Flight Procedures Cover Page	Task Action: FLIGHT CHECK	Task Type: IAP	Estimated Chart Date: 10/29/2026	APWS Task ID: 0CD5669AA86C494A99401A9C16FBAD47	APWS Project ID: 559B2A29478A451187291ECBD60A80D0
Procedure: RNAV (RNP) Z RWY 34L AMDT 1A		Enroute: NO	Specialist: Gorman, Barbara		Agreement Number:
Airport ID: KSLC			Airport City: SALT LAKE CITY		State: UT
Facility ID:	Facility Type:	Flight Inspection Remark Type: New FC Slot			
Procedure Comments: Processed IAW Technical Support Group (AJF-17) Memo dated 07/07/2021, Guidance for Procedural Changes Requiring Flight Inspection/Validation. ABBREVIATED AMENDMENT COMPLETED UTILIZING ACTIVE DATA FOR KSLC AND RWY 34L. KSLC_RNAV (RNP) Z RWY 34L_AMDT_A1A_1 INCLUDES RNP 0.10 TRAP WITH MA PENETRATOR. KSLC_RNAV (RNP) Z RWY 34L_AMDT_A1A_2 INCLUDES RNP 0.20 TRAP WITH MA PENETRATOR. KSLC_RNAV (RNP) Z RWY 34L_AMDT_A1A_3 IS FINAL TRAP WITH CONTROLLING OBSTACLES. CONTACT: CASIMIR TABAKA 405.954.7931 QUALITY 20 CHECKED QUALITY 9 CHECKED BEGUE

RNAV (RNP) Z RWY 34L
SALT LAKE CITY INTL (SLC)

Waiver 1 of 1

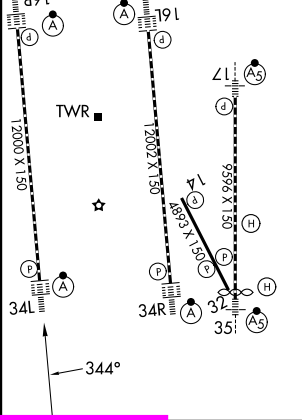
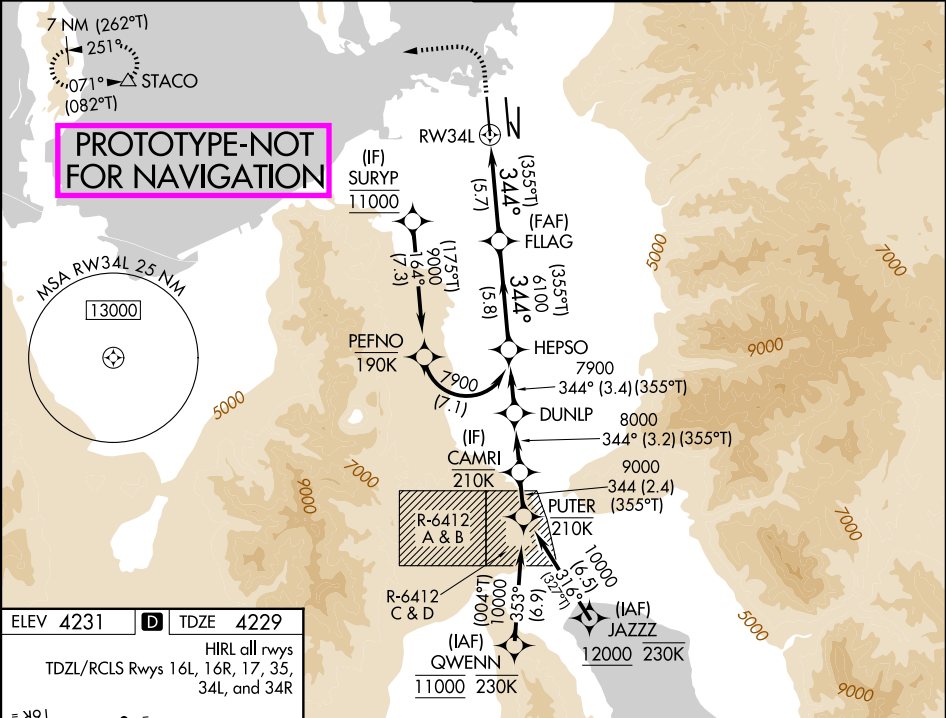
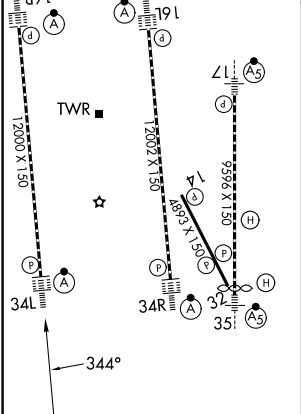
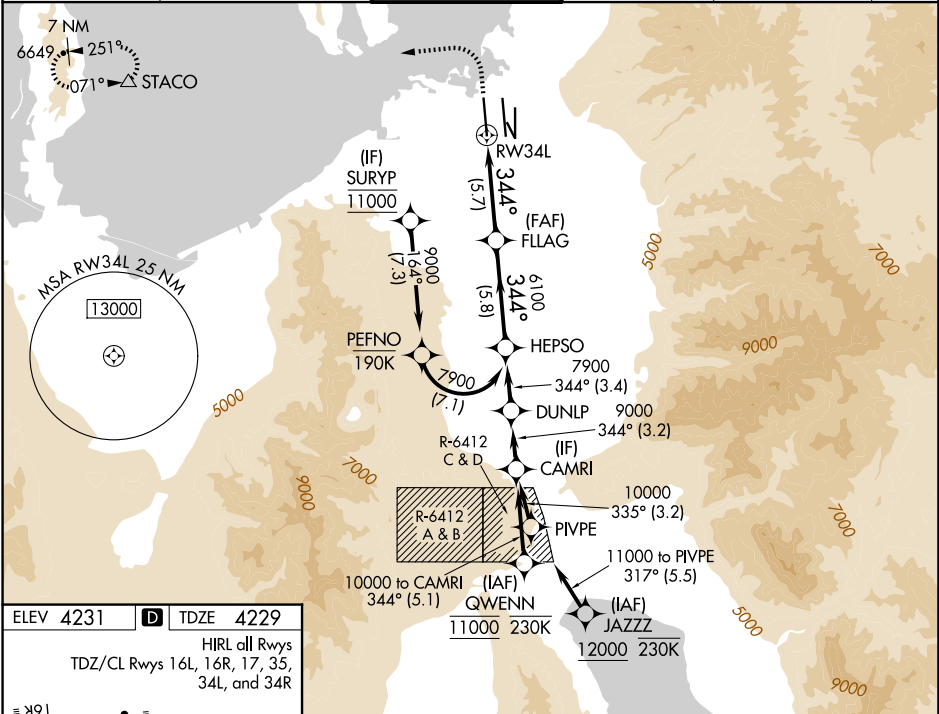
RNP AR APCH - GPS. Authorization required. From PEFNO: RF.	ALSF-2	MISSED APPROACH: Climb to 4800 then climbing left turn to 8100 direct STACO and hold.
For uncompensated Baro-VNAV systems, procedure NA below -9°C or above 54°C. Simultaneous approach authorized. For inop ALS, increase RNP 0.10, RNP 0.20 visibility all Cats to RVR 4500, RNP 0.30 visibility all Cats to RVR 6000.		*Missed approach requires minimum climb of 250 feet per NM to 4700.

RNP AR APCH - GPS. Authorization required. From PEFNO: RF.	ALSF-2	MISSED APPROACH: Climb to 4800 then climbing left turn to 8100 direct STACO and hold.
For uncompensated Baro-VNAV systems, procedure NA below -10°C or above 54°C. Simultaneous approach authorized. For inop ALS, increase RNP 0.10, RNP 0.20 visibility all Cats to RVR 4500, RNP 0.30 visibility all Cats to RVR 6000.		*Missed approach requires minimum climb of 250 feet per NM to 4700.
